**NUCLEAR REGULATORY COMMISSION**

Title: Advisory Committee on Reactor Safeguards  
Reliability and Probabilistic Risk Assessment

Date: Wednesday, February 19, 2014

# Coupled Level 1/2 Model - Cartoon

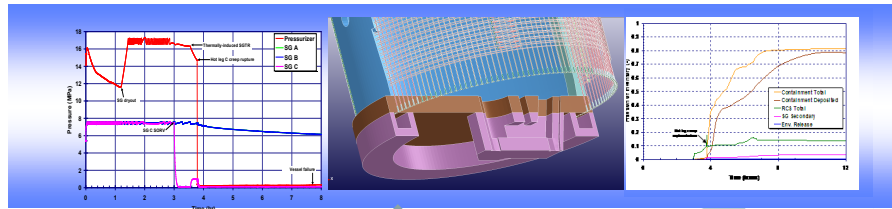
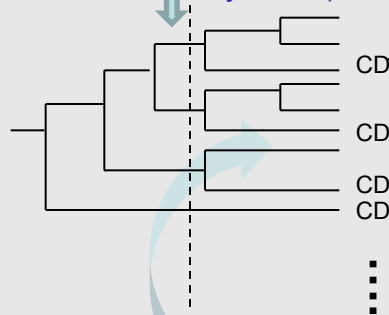
1                   Up here you show the bridge tree, the  
2           containment systems. That is pretty clear. And  
3           that just hooks onto the Level 1 trees in your  
4           process this one way. Then where all these funny  
5           arrows are going to the plant damage states, there  
6           is a thing called a plant damage set of event trees  
7           that really just I think are a set of rules for  
8           mapping each of those sequences into one of your  
9           plant damage states. That's true?

11                   MEMBER BLEY: And then you come over to  
12           the containment tree. There are a couple of things  
13           that get added in, I think it is the plant damage  
14           state event tree, which seems a little funny to me.  
15           One of them is about do I depressurize and yes or  
16           no. Is the primary depressurized on the core I  
17           think.

18                   Then over in the containment tree, you ask  
19           is the pressure high, medium, or low. And it would  
20           seem those two could link up such that you could  
21           have had that distinguishing in the plant damage  
22           state event tree and then it would just knock into  
23           the containment tree. Or am I missing something?

5                   MEMBER BLEY: Well, if I have sorted into  
6   pressurized depressurized, if I pressurize them when  
7   I get in the containment tree, if I came in  
8   pressurized, then there is a question if I am high  
9   or medium. And if I come over depressurized, the  
10   pressure is low. Is that true or how does that map?

24                   MR. HELTON: So the plant damage state  
25           tree is a sorting tree. It basically takes the golf  
26           balls and paints them different colors and drops  
27           them into different buckets. It doesn't change the  
28           frequency of the cut sets.
